RE: 1817 Bluffside NW
Grading and Drainage Plan
Engineer's Stamp Date: 08/17/19
Hydrology File: H11D015B

Based upon the information provided in your submittal received 08/19/2019, the Grading & Drainage Plan **is not** approved for Building Permit. The following comments need to be addressed for approval of the above referenced project:

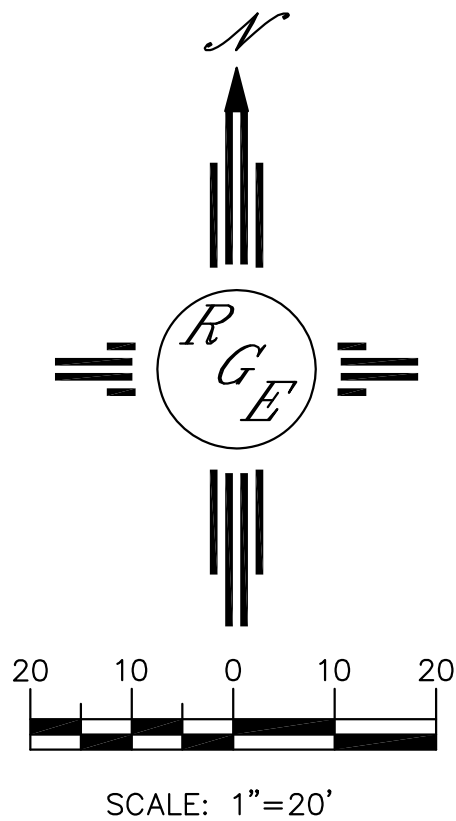
1. The topographic survey does not show the existing conditions along Casade Place correctly. As you can see in the July 24, 2019 photos show the vertical cuts that were not caused by drainage. This needs to reflect what the Owner's contractor graded within the public Right-of-Way along Casade Place NW.

2. Provide the existing and proposed grades on both sides of the proposed retaining wall.
3. Provide sections through all external boundaries showing proposed retaining walls, garden walls, property/ROW lines, existing and proposed grades. In accordance with DPM Ch.22, section 5 part B, grading and wall construction near the property line may not endanger adjacent property or constrain its use.

4. If the proposed retaining wall will create such an encroachment, written agreement from both landowners must be provided for such work. Written permission must include: signature of the property owner or owners representative, statement that undersigned is the owner or authorized representative, permission to construct the encroachment with a brief description of the encroachment.

5. Since the retaining wall Casade Place NW is actually holding up the public road because of grading done within the public Right-of-Way, a slope easement is needed. This slope easement will be sized from the property line along Casade Place with a 3:1 slope down to the existing grade. This is so if the retaining wall fails and it effects the public road, the City not replace the retaining wall but will put back a dirt slope at 3:1.

7. Please provide all required written agreement from adjacent landowners which were effective from the grading on their property. Written permission must include: signature of the property owner or owners representative, statement that undersigned is the owner or authorized representative, permission to grade on their property with a brief description of the extent of the grading.
8. Standard review fee of \$150 will be required at the time of resubmittal.
